Staff Report

Re: Sugar Town/Snelgrove Ice Cream Factory – Design Review
Petition PLNPCM2021-oo025

DESIGN REVIEW

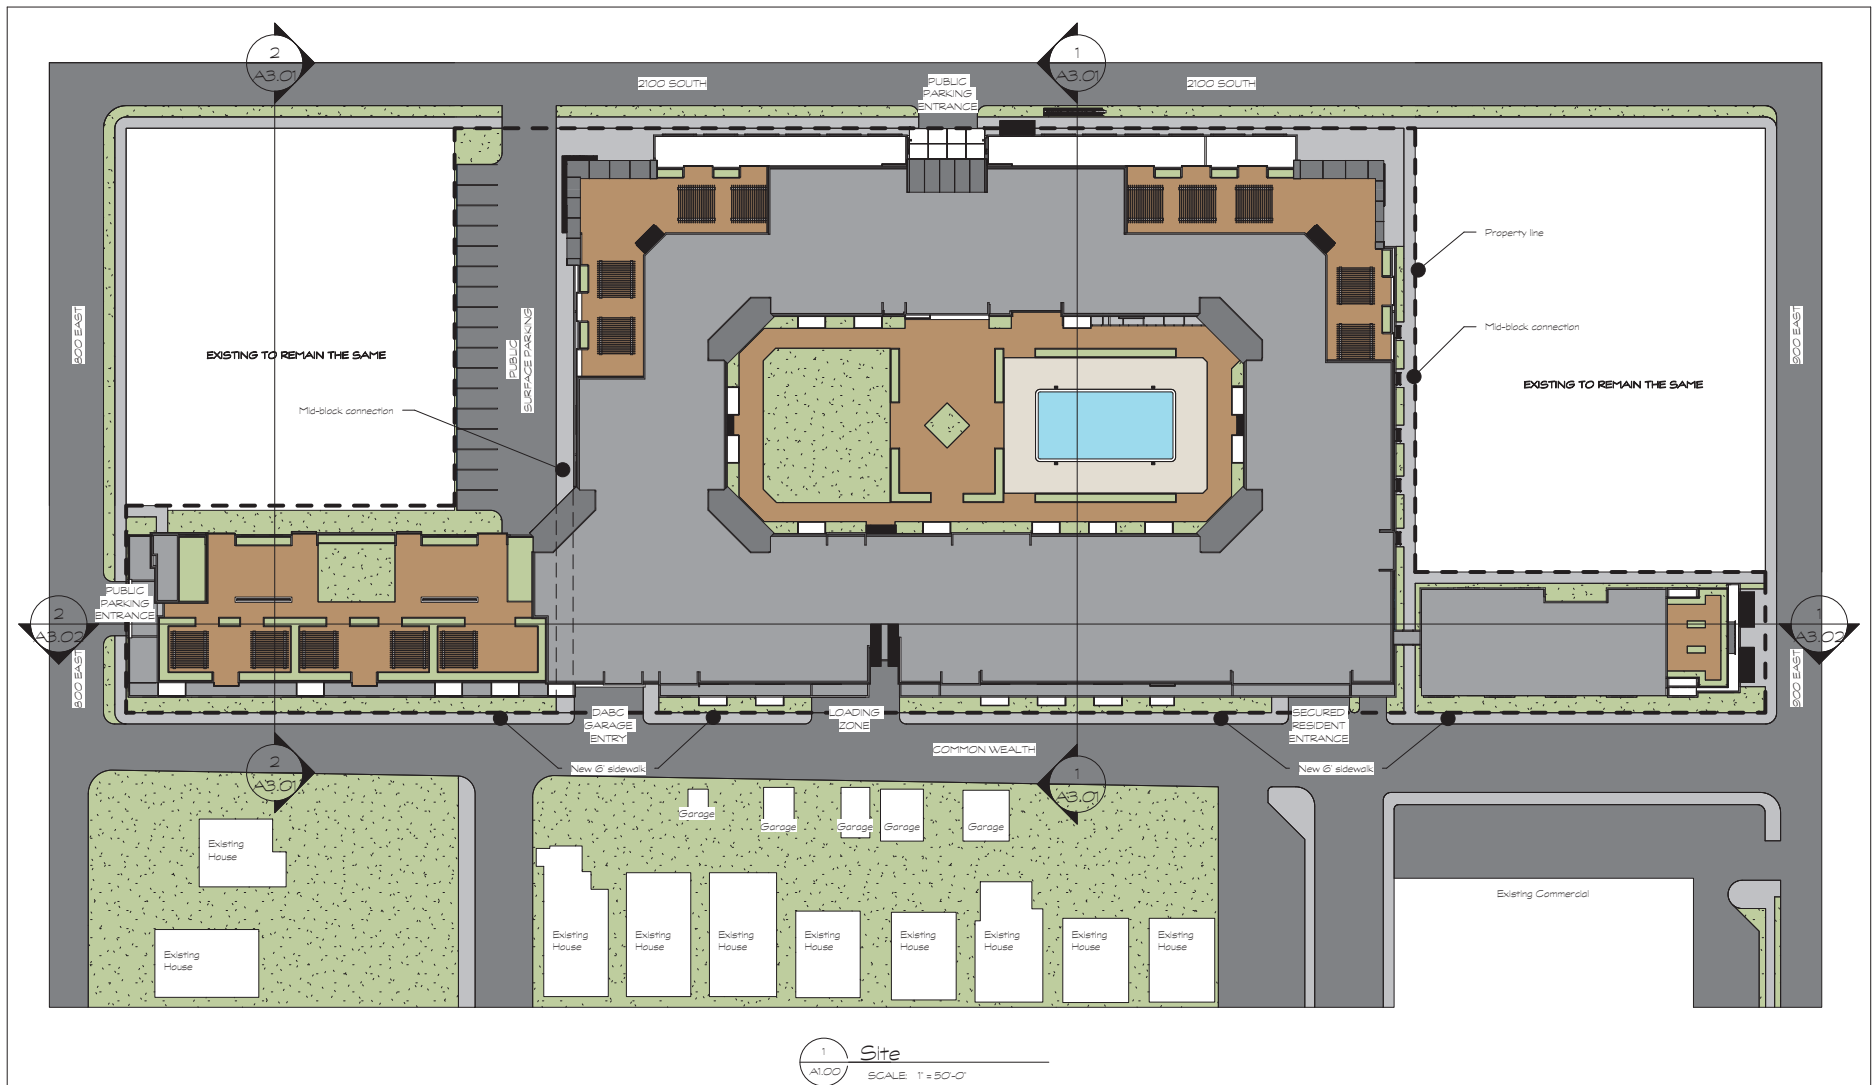
When looking at the north façade (2100 South) and associated floor plan, a proposed DABC State Liquor Store constitutes a substantial space (approximately 148') along this façade, and is located next to a 35' parking garage entrance which interrupts the façade in the middle of the building. This parking garage entrance is not pedestrian friendly and would only seem to cause pedestrian conflict as opposed to interest. The eastern portion of this façade is comprised of a very large residential leasing office and a fitness center of similar size. Planning Staff questions why the leasing office area, that would hold little to no interest to the public, would need to be so large and comprise such a large length of the street level façade. It seems like this is a missed opportunity for some retail or commercial space. With the exception of the liquor store, there is no space for commercial use along this stretch of 2100 South, which serves as a commercial corridor for the neighborhood, and therefore very little in terms of pedestrian interest. Planning Staff notes that there are only two building entrances proposed over this long length of street front (365'). The entrance to the liquor store is located on the eastern façade.

Overall Elevations - East & West

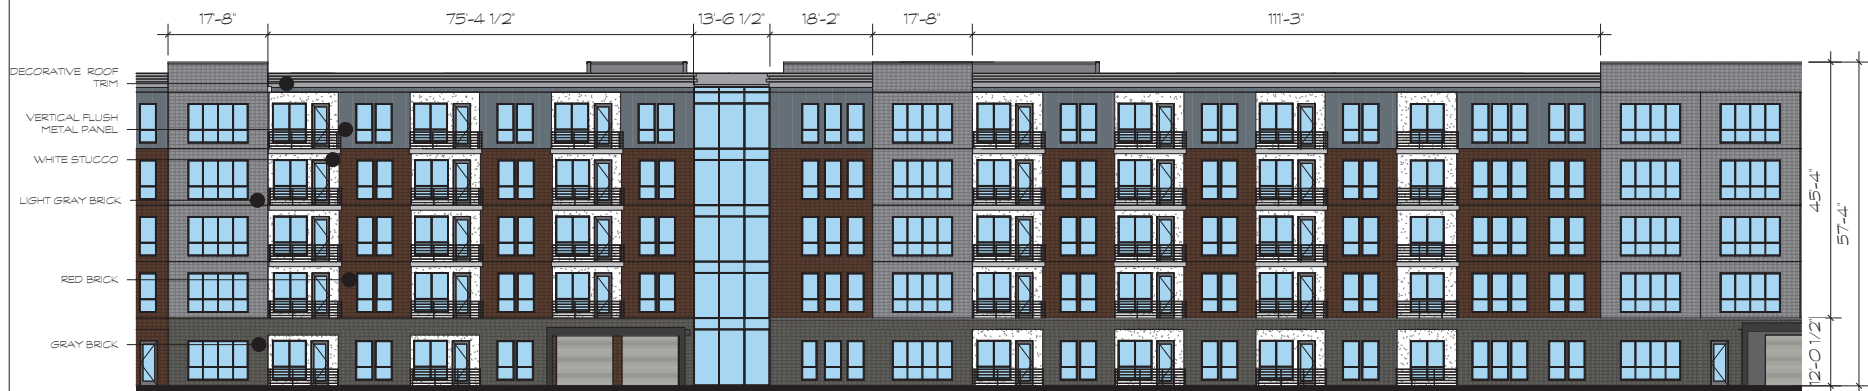
The east elevation at the street is labeled "Art Space" and appears to be retail or commercial in nature. The façade is transparent but there is no description of what this space will be used for and how it will enhance the pedestrian experience. Planning Staff notes that there is a bus stop directly in front of this façade.

Overall Elevations - South

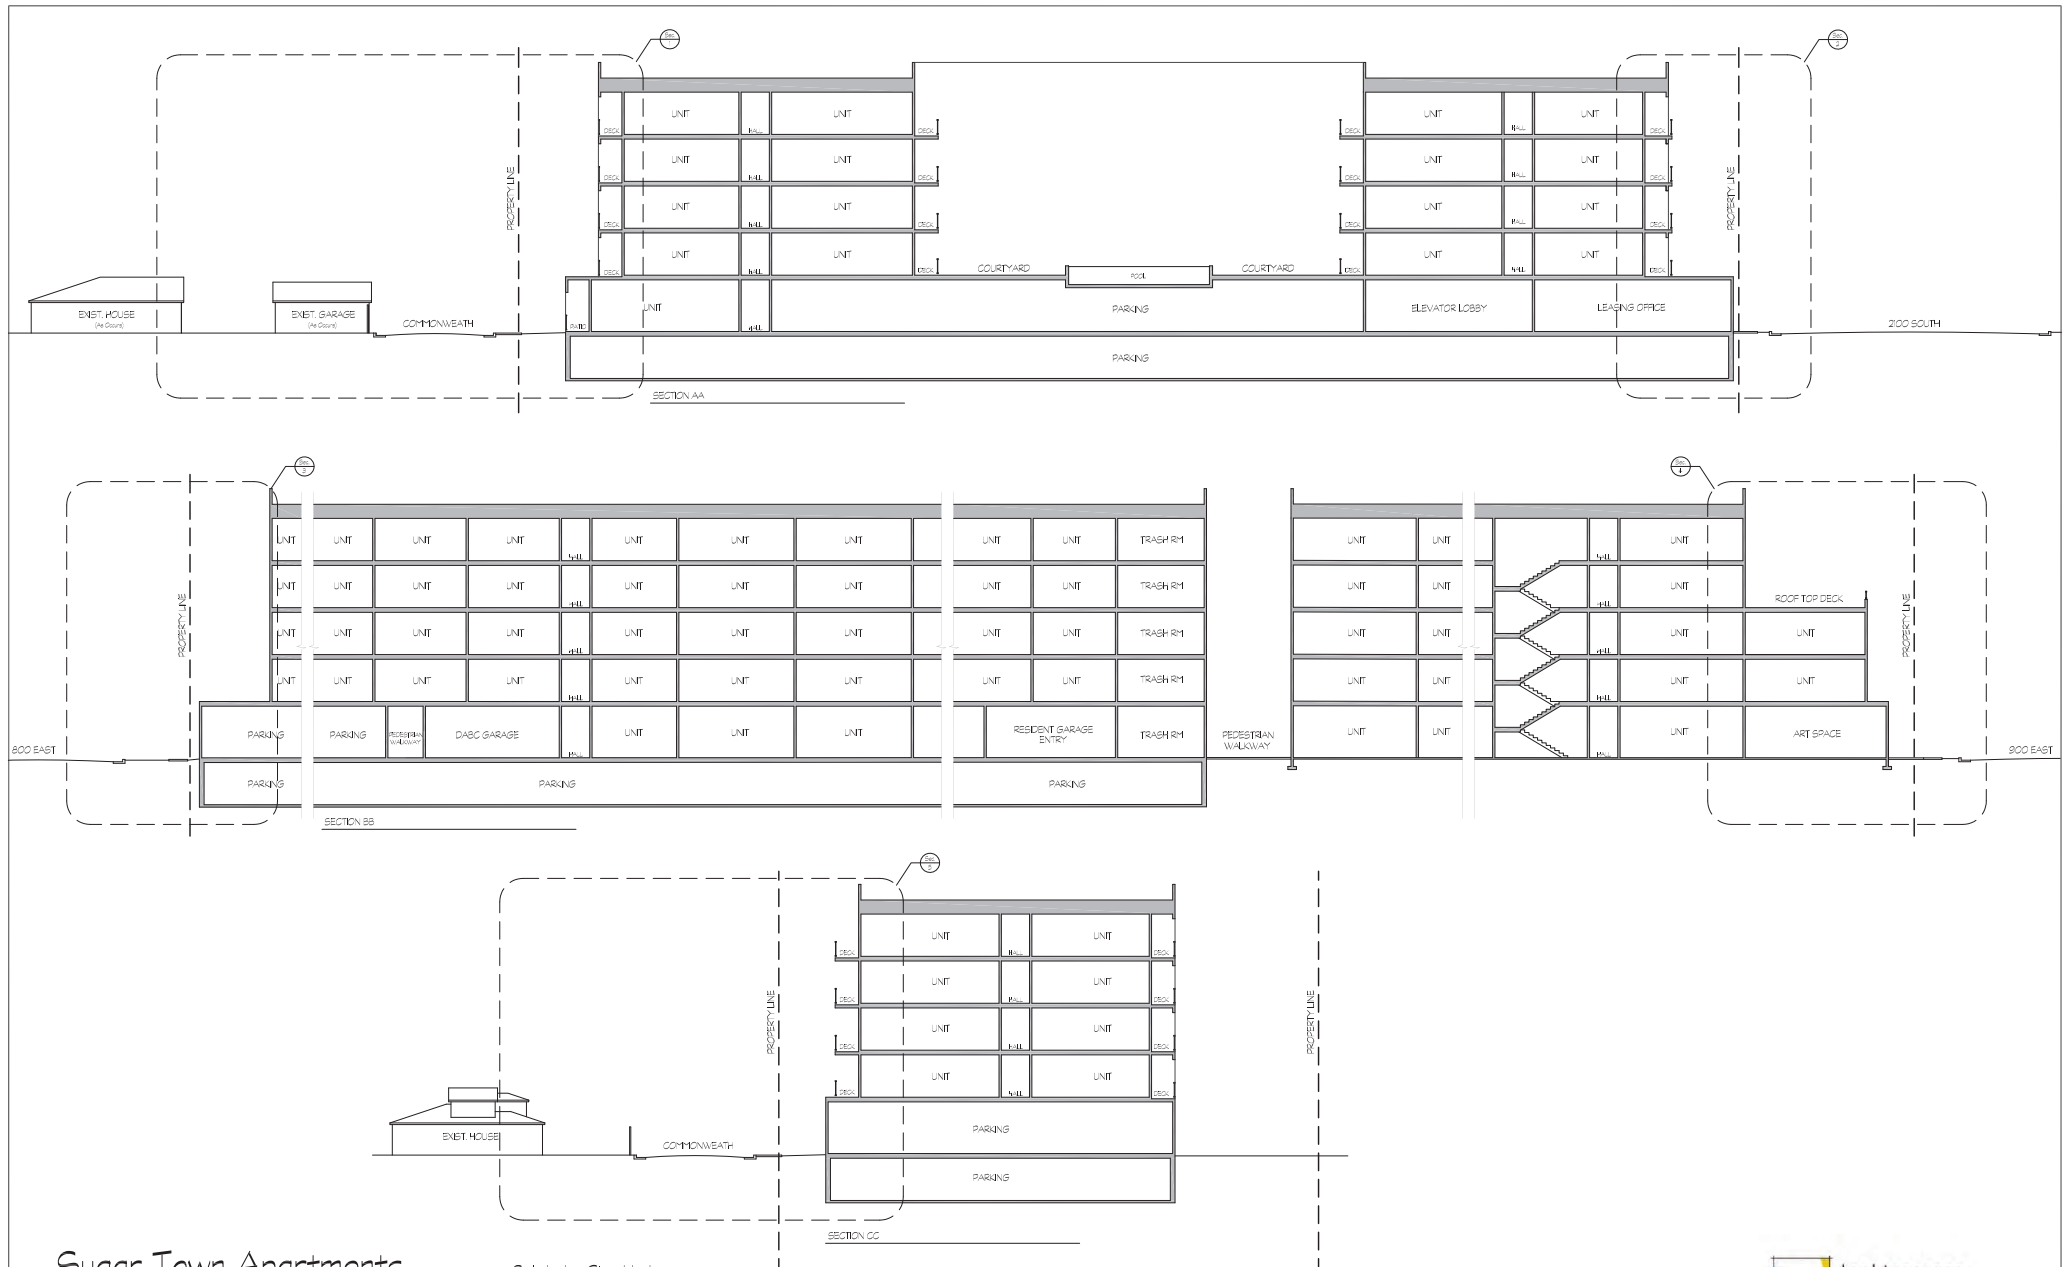
The south elevation (Commonwealth Avenue) at the street level on the western end, is composed of approximately 185' of enclosed ground level parking garage with windows at regular intervals. Planning Staff notes that the code requires active uses at the ground level at the street in the CSHBD zone and further states that parking should be located behind said active ground level uses. Could this large stretch of façade not be residential units similar to what is proposed toward the middle of this façade, effectively masking the parking? The middle portion of the façade shows six residential units that front the public street, which is positive, but there is no design detail provided indicating how these units interact with the sidewalk. The remaining eastern portion of this façade is more windows. This east portion, according to the floor plan consists of residential units, but there is no indication that these units have direct street access thereby providing activity and pedestrian interest. From the elevations and floor plans it seems like these units would be accessed internally via a hallway. Planning Staff notes that the street front ground level use along Commonwealth Avenue could benefit from more residential use to help transition into the residential neighborhood adjacent to the south.
